TBI-223000811

## DEUTZ\*\* – 223 0008 11 – 230/230 TGU6

**New design / Neues design / Nouvelle conception / Nuovo design / Nuevo diseño**

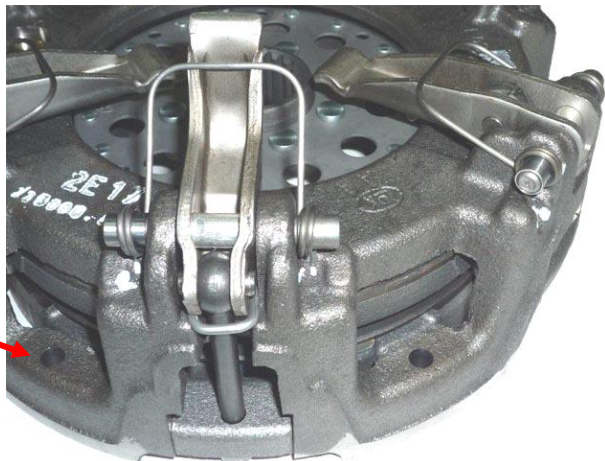
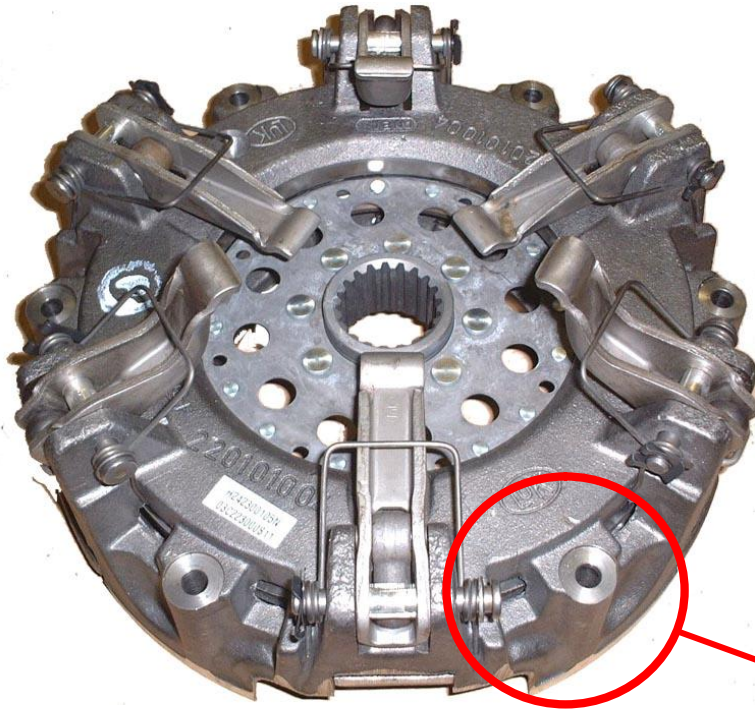
The new design utilises the latest clutch technology using a vented housing for improved cooling and heat dispersal.

**Fully interchangeable with existing clutches with no modifications required to vehicle or flywheel.  
New fixation bolt set 6 x M8 x 1.25 x 45mm is supplied with new designs to accommodate the lower housing.**
